RE: BAIADA INTEGRATED POULTRY PROCESSING FACILITY (SSD 9394) – SUPPLEMENTARY RESPONSE TO SUBMISSIONS

We are writing with respect to SSD 9394 for the Integrated Poultry Processing Plant at 1154 Gunnedah Road, Westdale. As you are aware, since the initial response to submissions was submitted on 3 July 2020, the Applicant has received additional submissions from various agencies and departments via DPIE. These matters have been raised and addressed in separate responses.

As requested, this correspondence has been prepared to provide a consolidate all the supplementary responses to submission and an updated set of development plans within a single document.

DRAWING TITLE: **B-DOUBLE SWEEP PATH (RENDERING TRUCK ROUTE)**

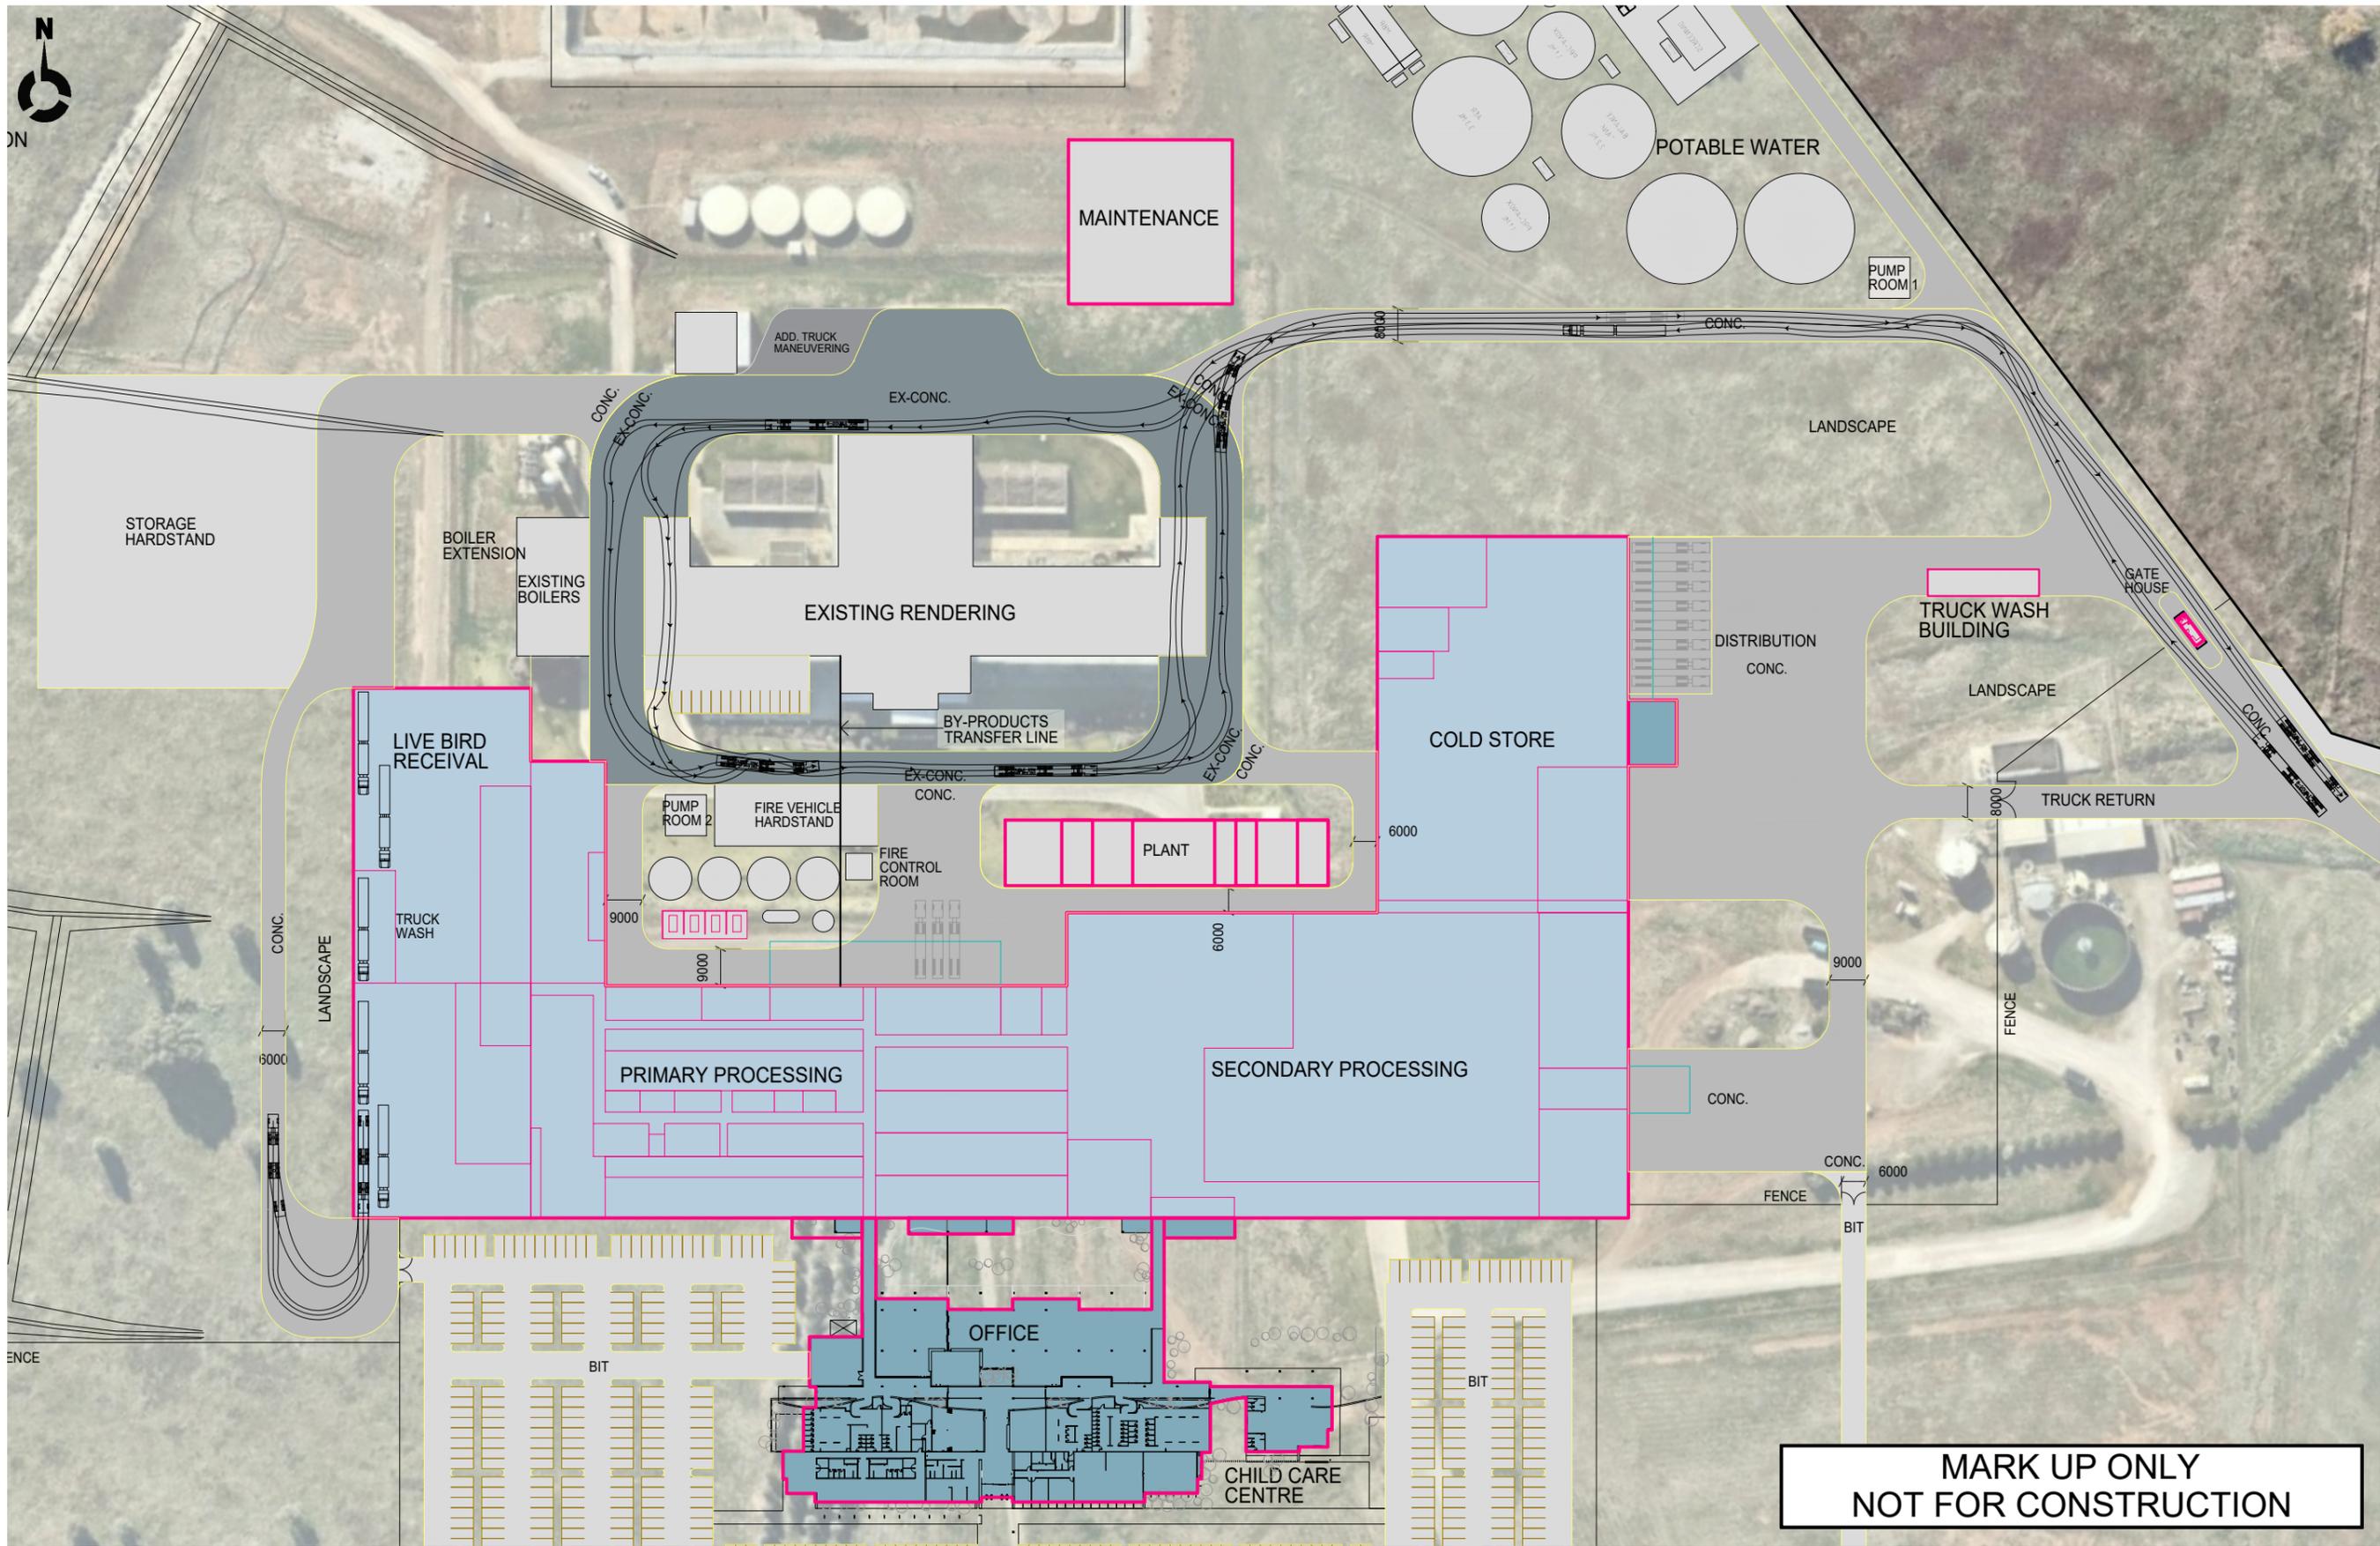
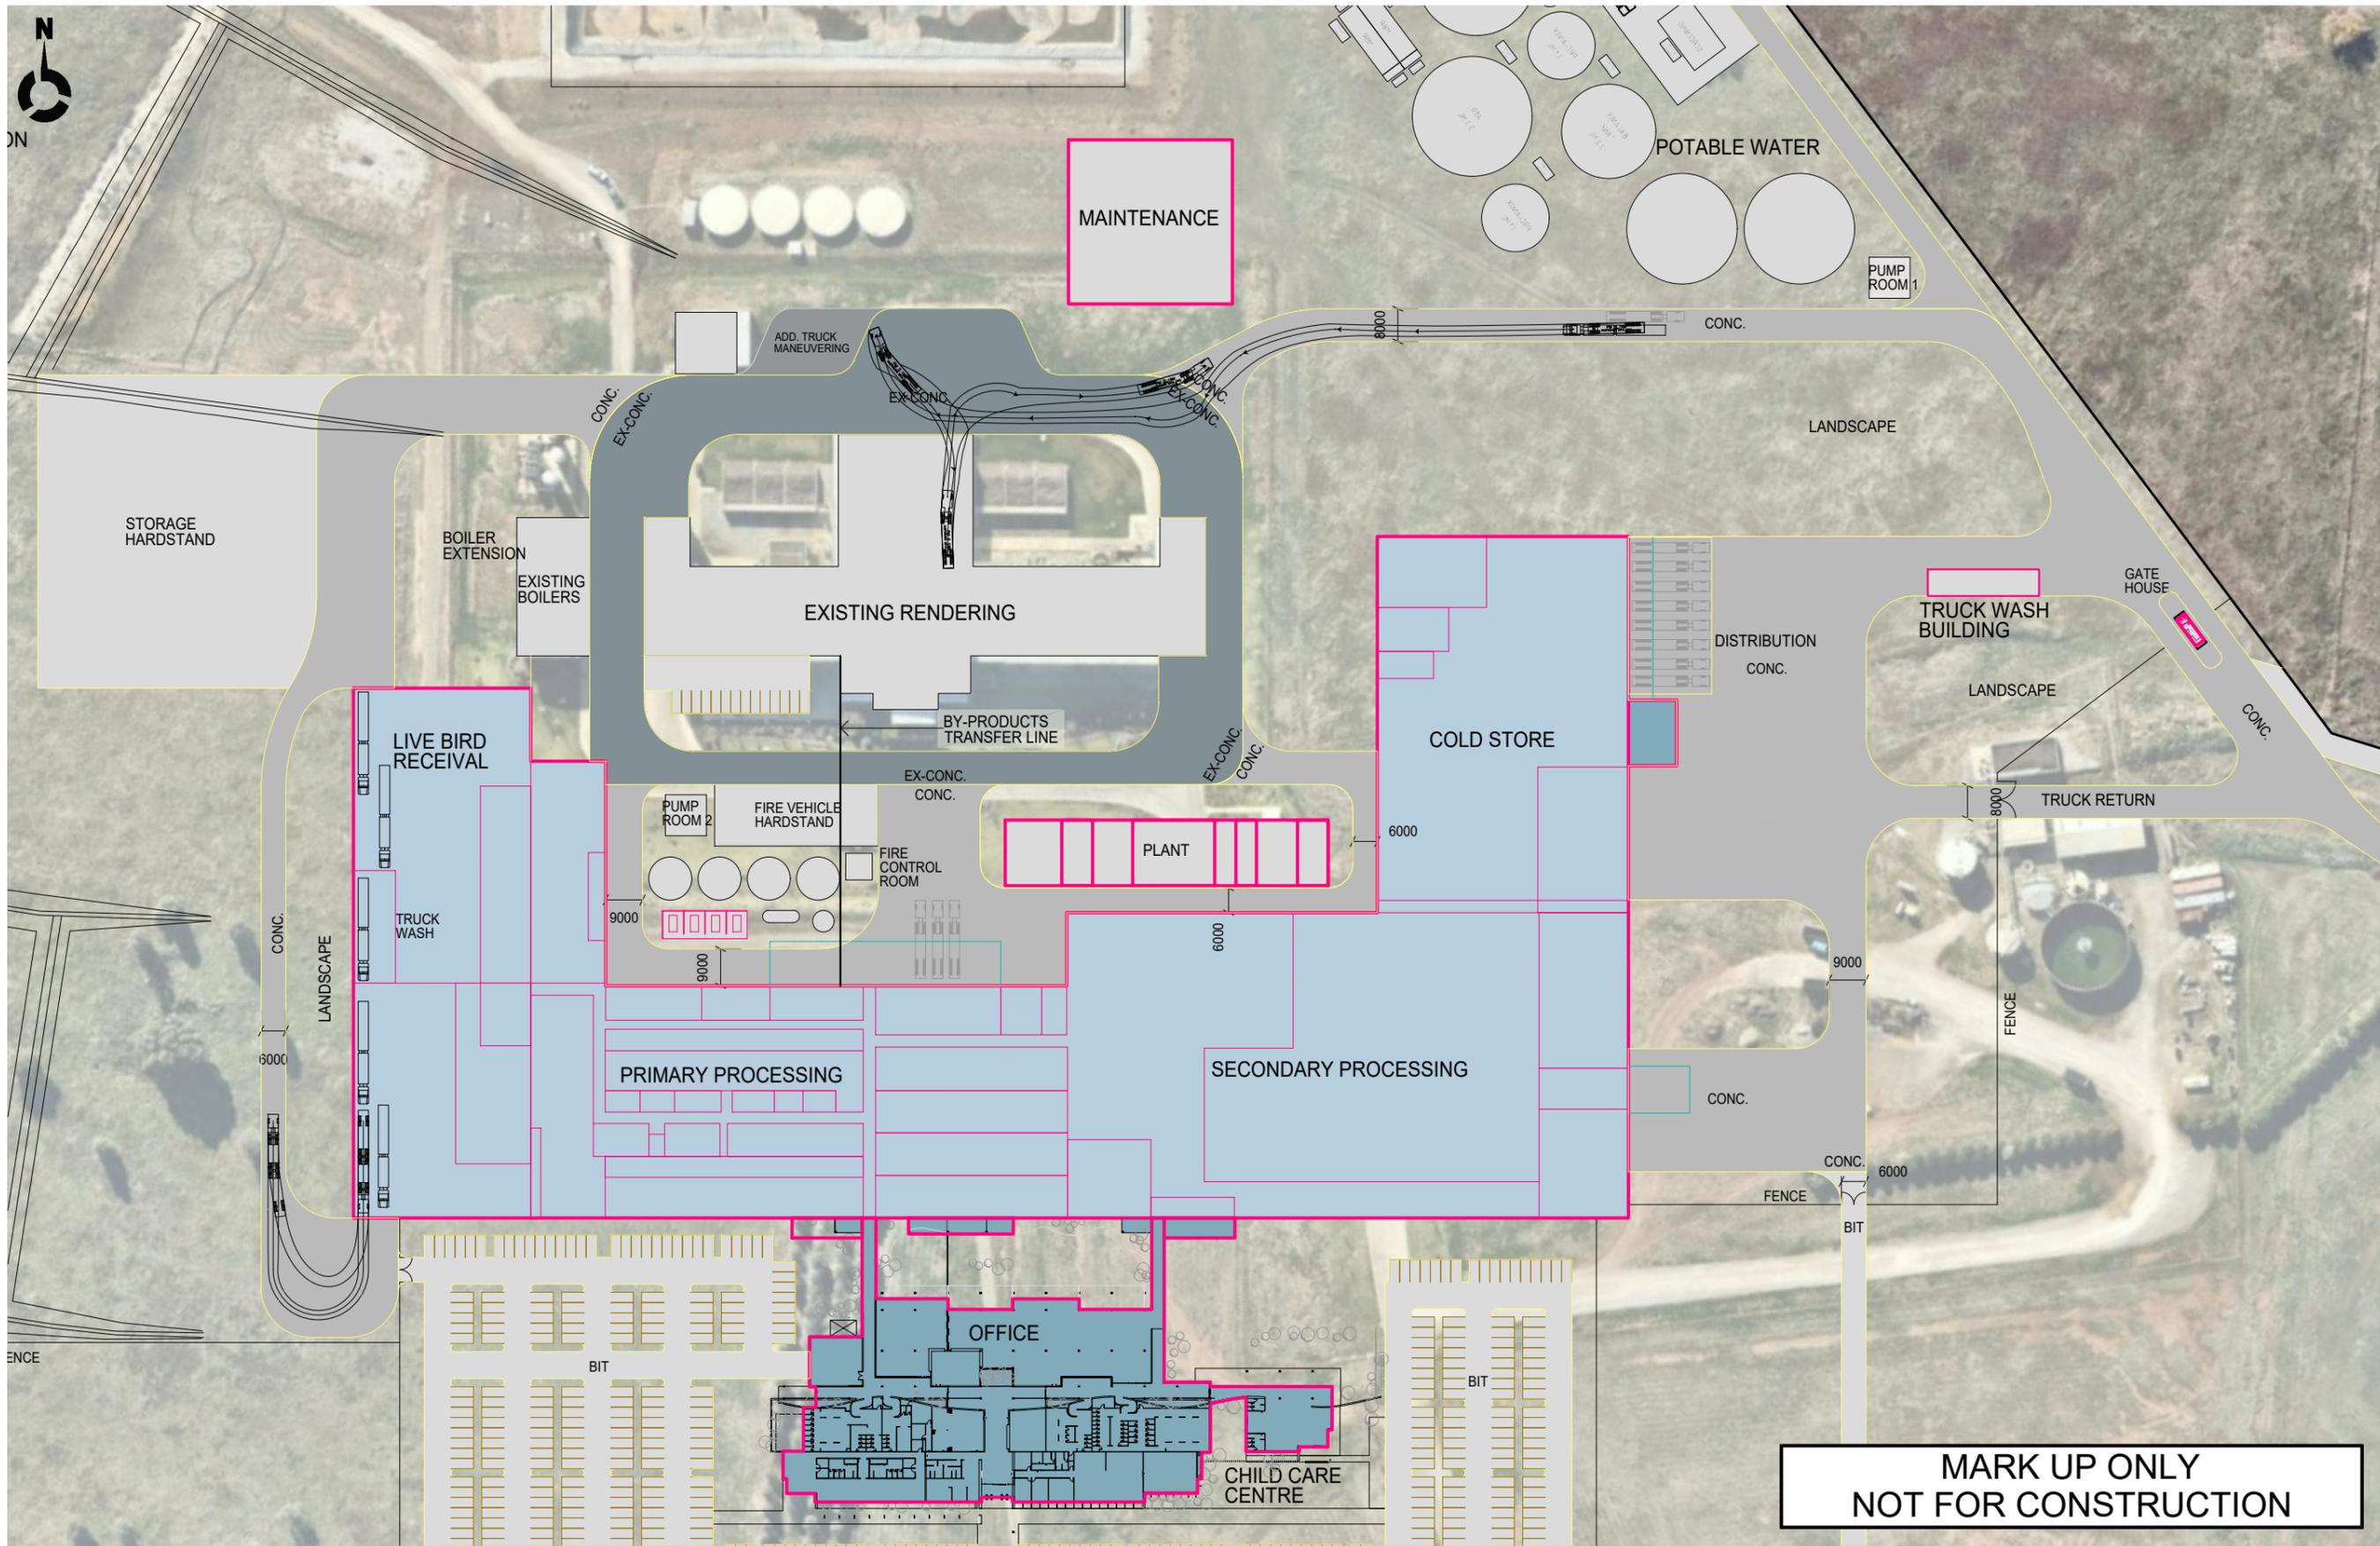
<ul style="list-style-type: none"> <i>The receipt and dispatch areas for rendering raw materials and finished rendered products appear unclear in the site plan. This should include swept path analysis of the largest vehicle (it is unclear whether a B-Double or a large rigid will be used as noted previously).</i> 	<p>Additional plans showing the swept paths as requested are provided as Attachment 1.</p> <p>The plans show the following activities:</p> <p>Live Birds: incoming and outgoing B-Double Trucks delivering birds to the live bird shed, parking in the marshalling area, and existing the site.</p> <p>Rendering Plant: incoming trucks (small rigid and semi-trailers) bringing material to the site for</p>

MATTERS RAISED	APPLICANT'S RESPONSE
	<p>rendering. Please note that all by-products from the new processing plant will be pumped via pipelines to the rendering plant, negating a large majority of the incoming trips with fresh material to be rendered on-site.</p> <p>Rendering Plant: B-Doubles collecting finished rendered products for transport off site.</p>
<ul style="list-style-type: none"> • <i>Identification of the truck marshalling area for both inbound and outbound trucks should be shown in the site plan. So that traffic flow can be safely and efficiently managed.</i> 	<p>Additional plans showing the B-Double swept paths are provided as Attachment 1.</p>
<p>2. TfNSW highlights that in determining the application under the Environmental Planning and Assessment Act 1979, it is the Consent Authority's responsibility to consider the environmental impacts of any roadworks which are ancillary to the development. This includes any works which form part of the proposal and/or any works which are deemed necessary to include as requirements in the conditions of project approval.</p>	<p>Noted.</p>
